NACELLE - EXHAUST - THRUST REVERSER OPENING ACTUATOR, COOLING HOSE - REPLACEMENT OF -
CATEGORY CODE 4 - MOD.NAC-78-0018

(1) Airplane: Airbus A320

(2) Nacelle: V2500-A1 Nacelles

V2500-NAC-78-0018

Replacement of Cooling Hose Assembly
Fig.1

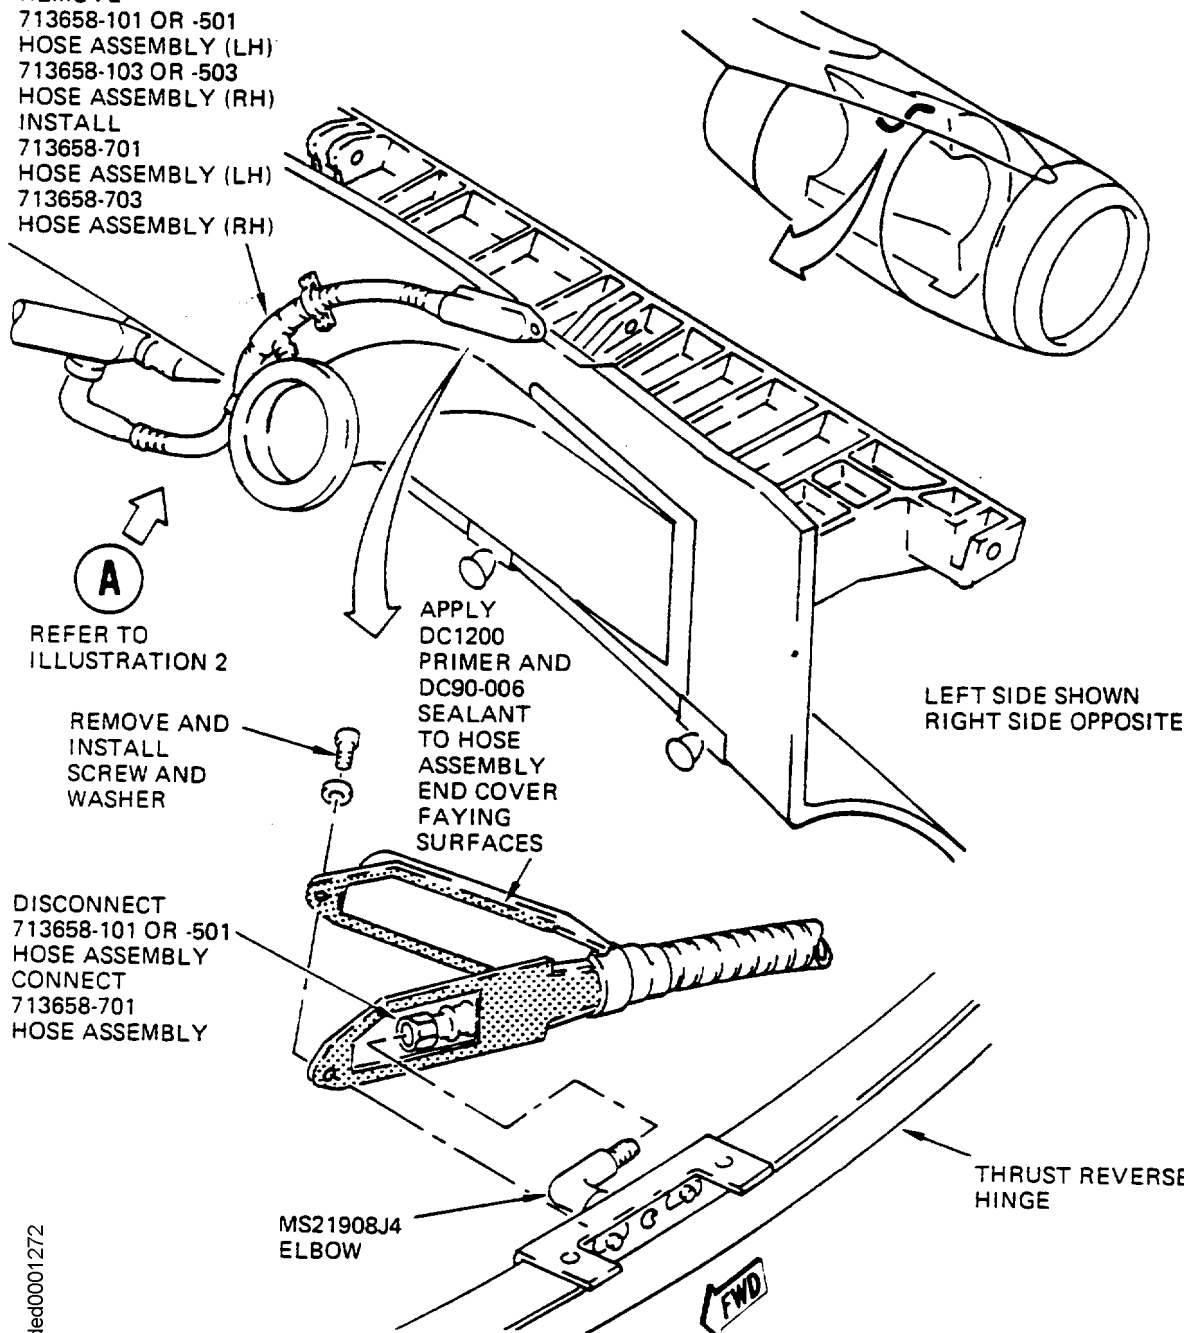
Remove and replace the existing cooling hoses from the left and right thrust reverser opening actuator with improved airflow cooling hoses.

REMOVE

713658-101 OR -501
HOSE ASSEMBLY (LH)
713658-103 OR -503
HOSE ASSEMBLY (RH)

INSTALL

713658-701
HOSE ASSEMBLY (LH)
713658-703
HOSE ASSEMBLY (RH)

- (1) Open the thrust reverser halves as specified in the A320 Aircraft Maintenance Manual, Task 78-32-00-010-010.
- (2) Find 713658-101 or -501 hose assembly on the thrust reverser inner barrel (Refer to Figure 1.)

- (1) Remove existing screw and washer that attach 713658-101 or -501 hose assembly end cover to the thrust reverser inner barrel. Keep screw and washer.

- (2) Pull back 713658-101 or -501 hose assembly end cover and disconnect coupling nut from MS21908J4 elbow.

- (15) Clean the hose assembly end cover faying surfaces using a cloth wet with MIBK. Wipe surfaces dry before solvent dries. (Refer to Figure 1.)
